**RE: Corps Review of Impacts of Proposed Floodway Alterations - Sammamish River**

The Corps will soon receive preliminary plans from King County for modification of this flood control project. This effort, known as the Willowmoor Project (Willowmoor), proposes to make changes to the floodway (aka Transition Zone or TZ) at Marymoor Park, as well as the weir - the control structure ahead of the TZ.

## Key Lake Sammamish Water Level Issues WSSA - Feb. 2016

**Update On Lake Sammamish Water Levels, Impacts, and Options**  
**M. Nizlek, PhD for WA Sensible Shorelines Association**  
**January 2017**

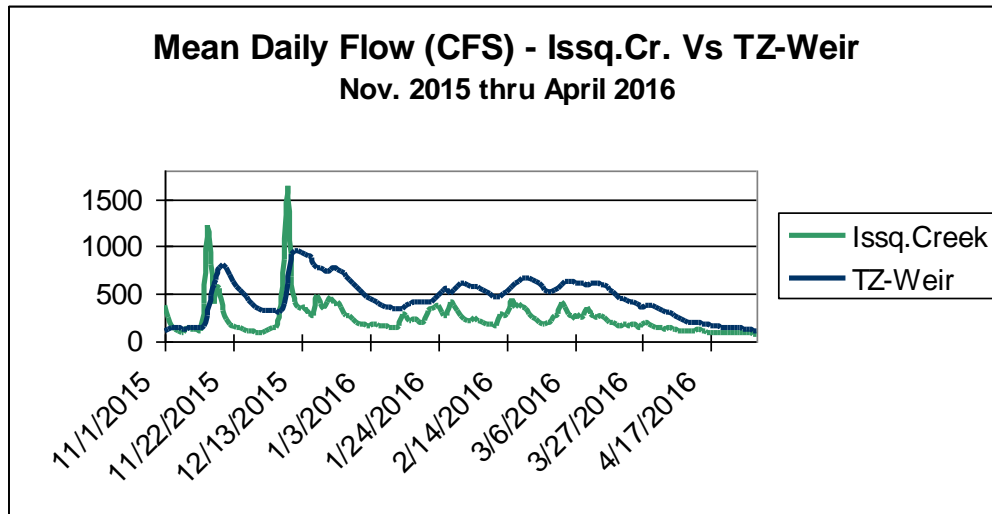
Historically, Lake Sammamish water levels remained at or below a level of 27 ft. (NGVD) for the bulk of the year. On average, for the first 40 years after construction, lake levels did not exceed 27 ft. for more than 60 days (2 months) each year. In the 1990's vegetation was placed along the edges of the low flow, center channel. Soon there after, King County ceased required annual maintenance. By 2010 the lake remained over 27 ft. for more than 200 days. Through persistence of residents, King County renewed annual brush trimming in 2011. The next year the County removed accumulated sediment, but only for half the length of the TZ. The net result has been an average annual period of 120 days per year above the 27 ft. OHWM; not the desired target of 60 days per year. And, unfortunately, the Willowmoor Project only aims to reduce the value to 90 days per year.

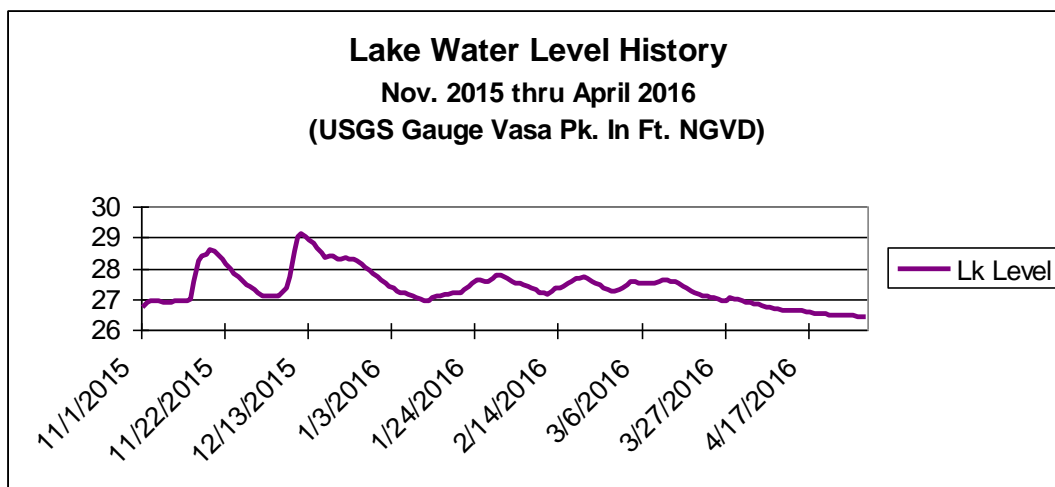
Facts reflected above include the following:

- 1) During the start of Water Year 2016 (i.e., Oct. 2015), two rainfall events occurred that resulted in Issaquah Creek exceeding an average daily flow of 1200 cfs (cubic feet per second).
- 2) But, in response to these two heavy inflows, flow at the weir into the TZ never reached 1000 cfs.

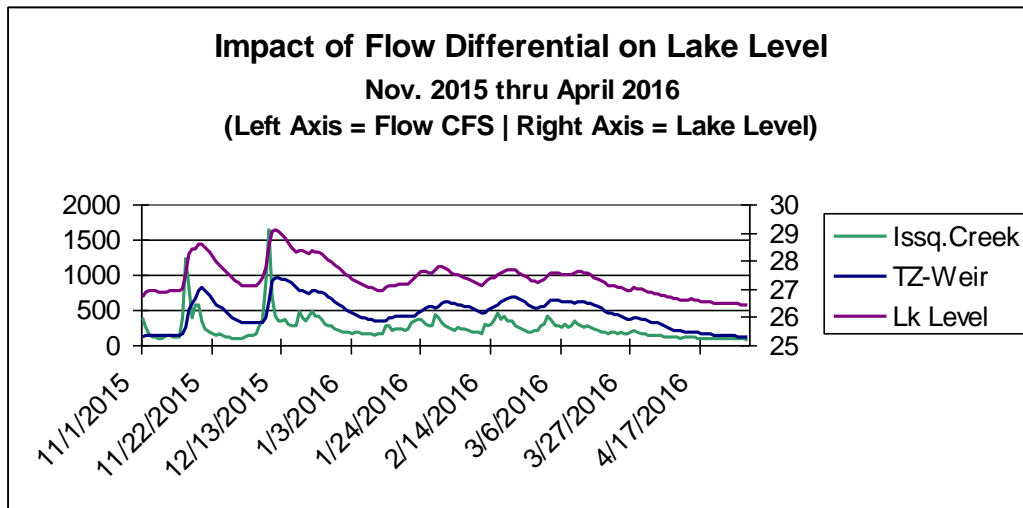
Observations that can be made here include:

- 3) Initially the lake had been under 27 ft. (NGVD). In November and December it rose above 28 ft., and peaked at more than 29 ft.
- 4) Except for a short period in early 2016, the lake remained at or above 27 ft. for more than 120 days into the spring.
